Nuclear Energy Institute PWR Sump Performance Task Force
Program to Address
Degradation of ECCS Performance by Sump Blockage

Evaluation Methodology Ground Rules
DRAFT 10-18-2002

**Subject: Head Loss Behavior on ECCS Screens and Strainers
from Fibers and Particulates**

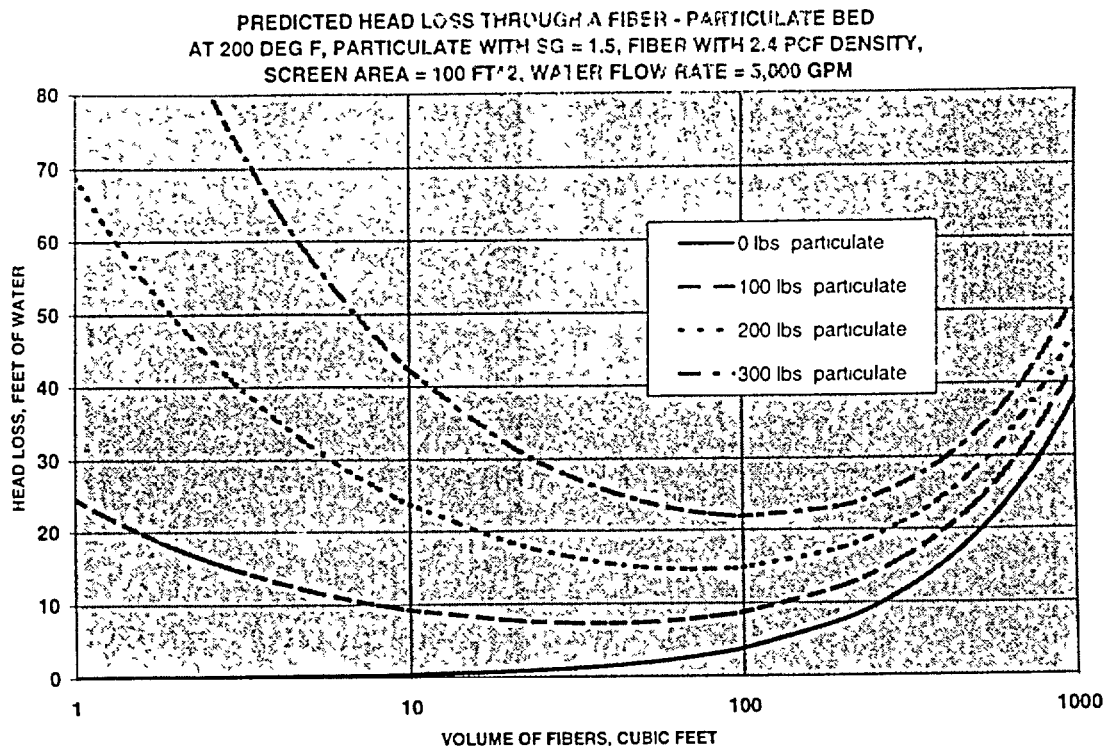
The design conditions identified on the above graph are representative for many US PWR plants. I began the graph at 1 ft³ of fibrous debris because on a 100 ft² screen, that corresponds to a debris bed thickness of 1/8 inch. Your contractors have shown that debris beds have not yet formed until the fiber bed is at least 1/8 inch thick.

As can be seen from the graph above, the relationship between fibers with particulates and head loss is not intuitive. For example, it clearly shows that a very small volume of fibers with a given level of particulates will cause much higher head losses than a moderate level of fibers. Most people initially see this as illogical. Intuitively, most plant personnel generally believe that less fibrous debris is always better than more fibrous debris. Herein lies the root of a misunderstanding that we believe is so widespread. The curves on the above graph, based on the NUREG/CR-6367 head loss equation, are typical and are applicable for the post-LOCA ECCS design conditions of PWR plants.

To further illustrate this point using the above graph, it is clear that a fibrous debris bed of around 100 ft³ yields the lowest head loss for the specific design conditions above (depending on quantity of particulate). If we reduce fibrous debris to say 5 ft³, such as by removing fiberglass insulation from inside containment, the head loss increases from ~ 22 feet to something more than 50 feet of head loss with a particulate level of only 300 lbs.

And so, contrary to the logic that fewer fibers will lower the head loss, fewer fibers will actually increase the head loss across 100 ft² ECCS screens, up to about 100 ft³ of fibers. If we test the other end of the graph, and increase fiber volume to 1,000 ft³, the head loss is about 52 feet with 300 lbs. of particulate. Compared to our starting point of 100 ft³ of fibrous debris, the intuitive logic holds true since head loss increases when fibers are added to the debris on the screens. But it is not true when compared to any volume of fiber that is left of the optimum volume, or to the left of about 100 ft³.

And so, in conclusion, I am urging the NRC to assist in remedying the widespread misunderstanding of the dependency of head loss on volume of fibrous debris and particulates. I suggest that you do this in future public meetings or workshops in which you and your contractors participate. PCI's representative would be glad to meet with you to explain our concerns in more detail, if that would be helpful.
